RESPONSE TO REQUEST FOR ADDITIONAL INFORMATION

APR1400 Design Certification

Docket No. 52-046

RAI No.: 338-8426
SRP Section: 08.01 – Electric Power – Introduction
Application Section: 8.1
Date of RAI Issue: 12/17/2015

Figure 1 Simplified Single Line Diagram of APR1400 Offsite Power Circuits

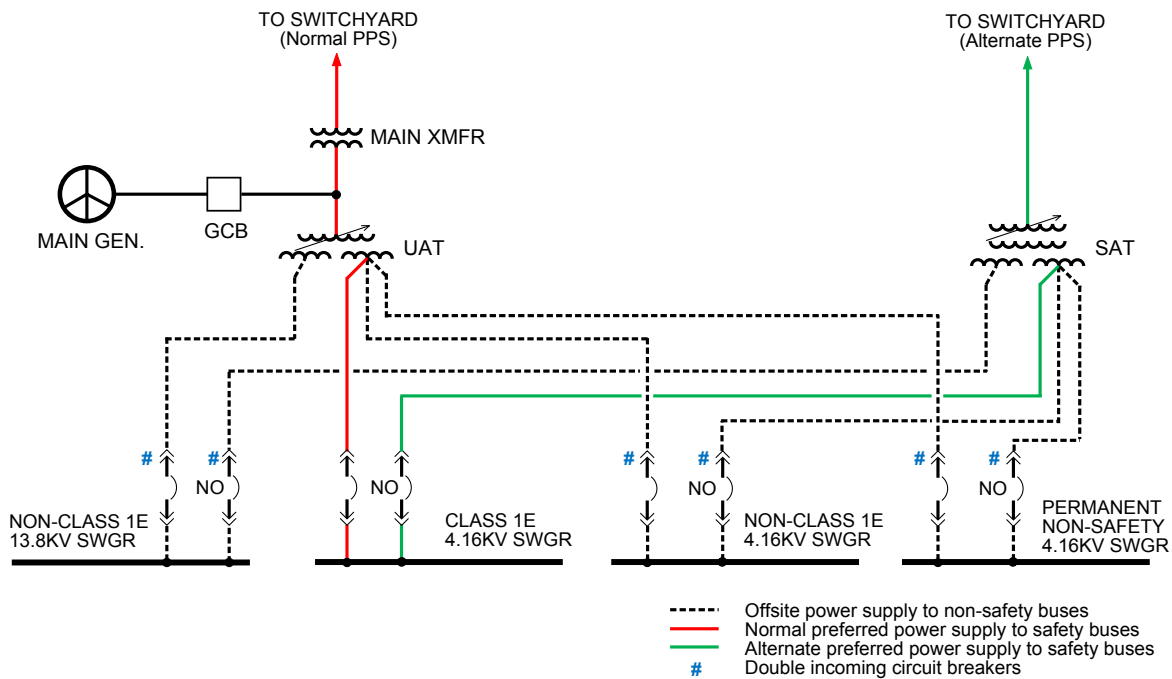
The staff has reviewed the applicant's responses and determined that in accordance with SECY-91-078, the Commission requires evolutionary advance light water reactor (ALWR) design such as APR 1400 should include an alternate power source to the non-safety loads unless the design can demonstrate that the design margins in the evolutionary ALWR will result in transients for a loss of non-safety power event that is less severe than those associated with the turbine trip only event in current existing plant designs. SECY-91-078 also states that the staff's position is that at least one offsite circuit to each redundant safety division should be supplied directly from one of the offsite power sources with no intervening non-safety buses, in such a manner that the offsite source can power the safety buses upon failure of any non-safety bus.

The applicant states that the APR1400 offsite power system is designed in accordance with IEEE Std. 765, which provides detail design guidance and design criteria to properly meet GDC 17. However, the NRC staff has not endorsed IEEE Std. 765 in applicable RGs (RG 1.32, RG 1.75). IEEE Std. 308-2001 guidance as endorsed by RG 1.32, states that the non-Class 1E circuits shall meet the independence and isolation requirements as established in IEEE Std. 384-1992. IEEE Std. 384-1992 guidance as endorsed by RG 1.75 states that the applicant should follow the guidance in IEEE Std. 384 to address independence and isolation of Class 1E and non-Class 1E circuits. The staff believes that the new proposed enhanced design still does not meet the intent of the GDC 17 and the Commission direction in SRM-SECY-91-078, and that further explanation is needed.

The applicant is requested to provide explanation as to how the proposed design meets GDC 17 requirement, and guidance in SRP 8.3, SECY-91-078, RG 1.32, RG 1.75, and applicable industry standards or provide analysis to demonstrate that the design margins will result in transients from a loss of non-safety power event that is less severe than those associated with the turbine trip only event in current existing plant designs. The applicant is requested to discuss how the electrical system provides a direct connection with no intervening non-safety buses from the offsite power source to the onsite Class 1E system.

The APR1400 has a normal preferred power supply (PPS) connection through the unit auxiliary transformers (UATs) and an alternate PPS connection through the standby auxiliary transformers (SATs) to the onsite power system.

Under normal power operating conditions, the safety and non-safety related loads (including permanent non-safety loads) are supplied from the UATs. If power from the normal PPS is unavailable, the offsite power source for the Class 1E and non-Class 1E onsite power system is automatically transferred to the alternate PPS through the SATs. The UATs and SATs supply offsite power to both the safety and non-safety loads from the same connected 4.16 kV secondary winding.

A simplified single line diagram is depicted in Figure 1 to illustrate the APR1400 offsite power circuits. For simplicity, the diagram shows only one electrical division and the buses of the same classification and voltage level are indicated as one bus.

The APR1400 does not need to utilize the third path like the ALWR generic design since the offsite power sources of APR1400 have direct connections to the Class 1E buses. Failure of the non-Class 1E bus will not disable or disconnect the normal or alternate path from the offsite power supply to the Class 1E buses.

As stated previously, the offsite power source to the APR1400 has direct connections to the safety buses such that the offsite power supply will not be prevented from supplying power to the safety buses upon a failure of any non-safety bus. The direct connection is normally maintained for the APR1400 design as shown in Figure 1 and also adequately secured in the event of a problem with any non-safety bus by proper isolation of the faulted non-safety bus.
